### **36C24926R0013 Replace Site Underground Chilled Water Piping – RFIs**

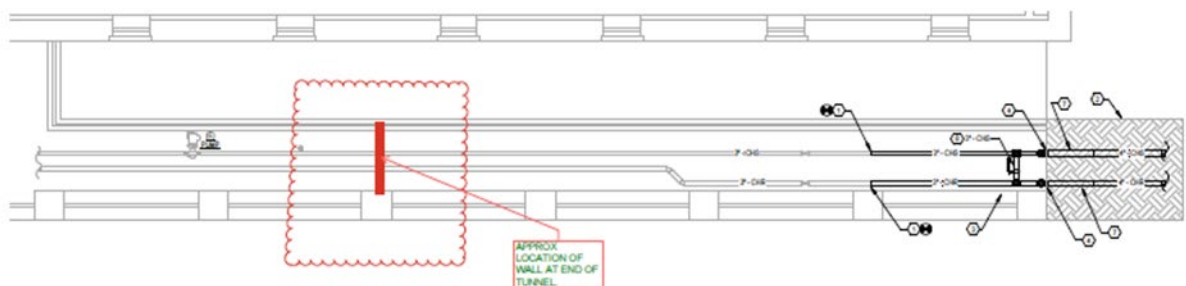
32. The Solicitation requires submission of three (3) Past Performance Questionnaires to be completed by prior clients and forwarded directly to the Contract Specialist in order to satisfy Factor 3 – Past Performance.

**Response: Yes**
